# DRAFT COMMISSION ORDER

**SEGS VIII**

*Biology Condition 4(f)*

Docket No. 88-AFC-1C

**SHEET IMPROVEMENT PLANS**

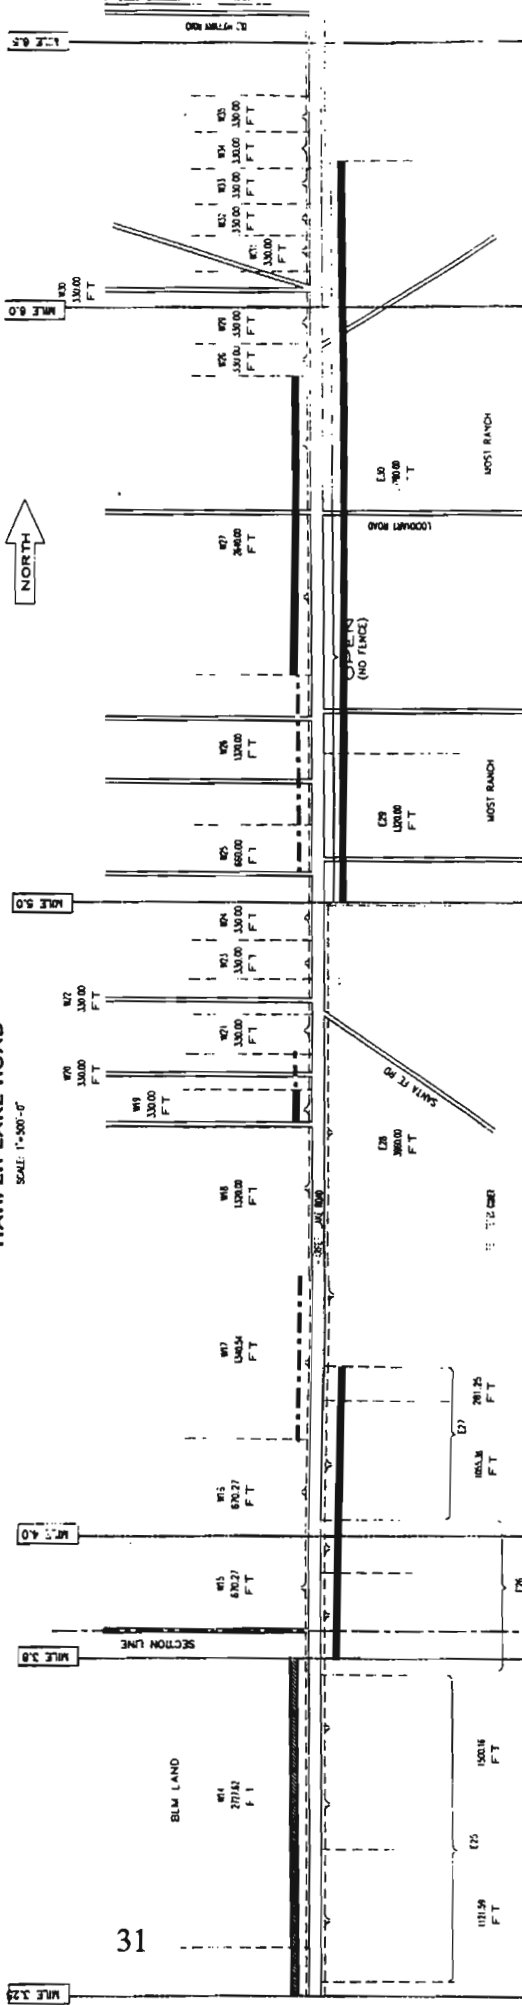
These solicitation results are shown on Exhibit 1, a map of all parcels on Harper Lake Road. One owner who was unwilling is Mr. Most, owner of the largest privately held parcels at the north end of Harper Lake Road. These parcels, identified as the Most Ranch, are cultivated for agricultural operations. In addition, there are three concentrations of unwilling owners almost evenly distributed along the east side of Harper Lake Road.

This is not just a hypothetical circumstance. For example, if any of the block of owners on the east side of the Road (Ex. 1, parcels E 15 - 21) does not grant a fence easement, the resulting gap would be facing 3.5 miles of continuous fence on

Lastly, the Committee thoroughly reviewed Exhibit 1 for patterns of ownership and parcel sizes and then considered the testimony concerning back-lot-line fencing and concluded that 5 percent linear non-participation on each side of the Road represented an appropriate threshold. Five percent is 1,716 feet on the west side, and is 1,320 feet on the east side. While such linear distances are less restrictive than the goals established by the fence proponents, they nevertheless represent an overwhelming percentage of the distance which appears fenceable *as a practical matter*.

Thus, the Committee establishes 95 percent linear distance participation on each side of Harper Lake Road as the minimum threshold to permit the release of HLC's mitigation funds for procurement of fencing materials and actual construction of the fence. Since the Committee also endorses the use of side-lot-line fencing, the linear distance used to calculate achieving the threshold shall be only that footage paralleling Harper Lake Road on a north/south axis. Since the expert testimony did not endorse a fence only on the west side of Harper Lake Road, the attainment of the threshold levels must occur on both the west side and east side of Harper Lake Road.
